**SUBMISSION TO
THE LEVEL CROSSING REMOVAL AUTHORITY –
ESSENDON JUNCTION (BUCKLEY STREET)
GRADE SEPARATION OPTIONS**

Figure 3 Inaccuracies in the LXRA consultation image

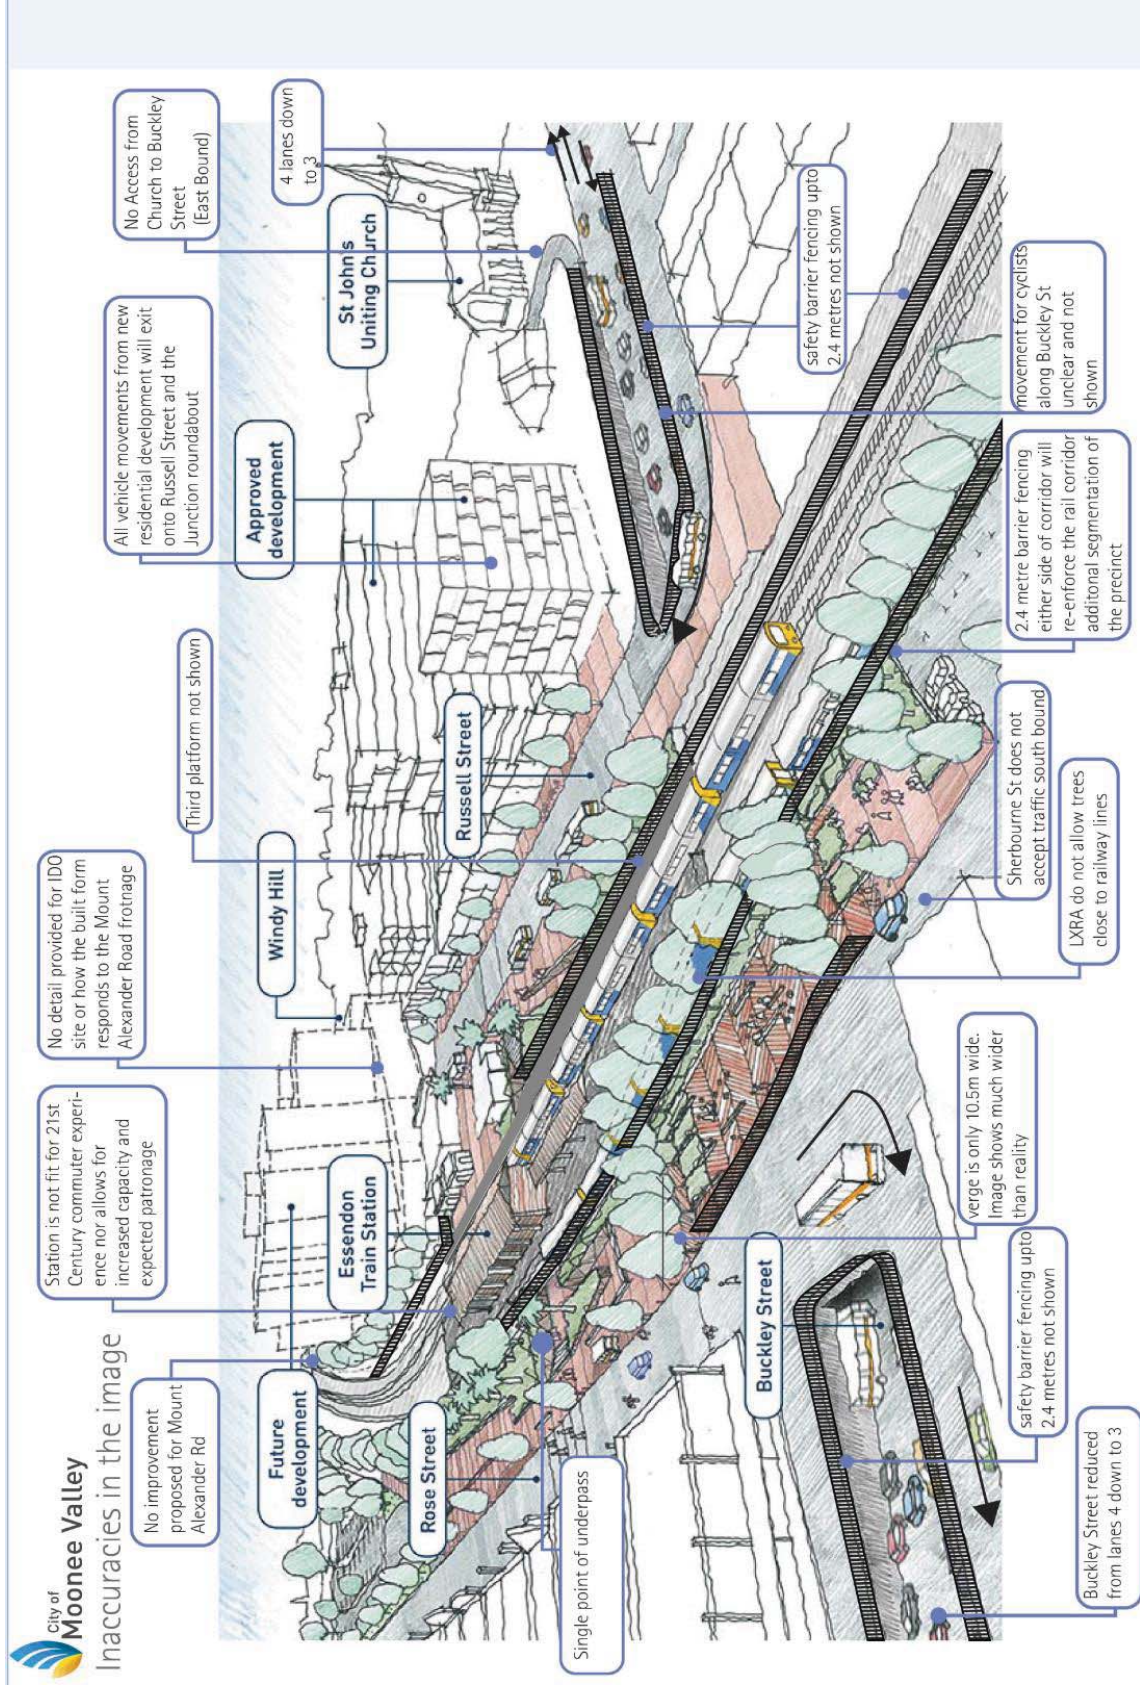
Figure 3, on page 20 presents the inaccuracies in the artist’s impression used at the community consultation in November / December 2016.

6.9 Materials and Finishes	<p>96. Limited detail has been provided to Council regarding proposed materials and finishes to the road trench.</p> <p>97. Council considers the release of an inaccurate artist impression to be a substandard approach to the communication of a design solution when other level crossing options have provided realistic photo montages to inform the debate about options moving forward.</p>

26. The brochure of the preferred option needs to be updated to accurately show both pedestrian and cyclist access through the road trench as well as details of barrier fencing.
